Access Compliance Report Public Rights-of-Way (Pedestrian Signals)

Main Street: MESA_DR Cross Street: IRVINE_AVE Location: SE

ADA ID: SGAT220128133042 Signal Type: One Push Button-Non APS Overall Compliance: No Severity Scores: BTN 1: 35 BTN 2: N/A No BTN: N/A

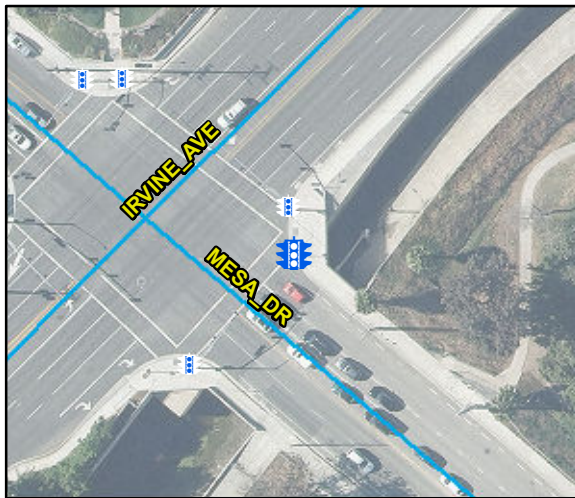
Surveyor Notes: Button 2 for Bike Lane

OC Std/PROW: R404.2, R404.3, R403.4, MUTCD 4e.08

Possible Solutions: Replace Signal Push Button With APS Button. Remove and Replace Clear Space.
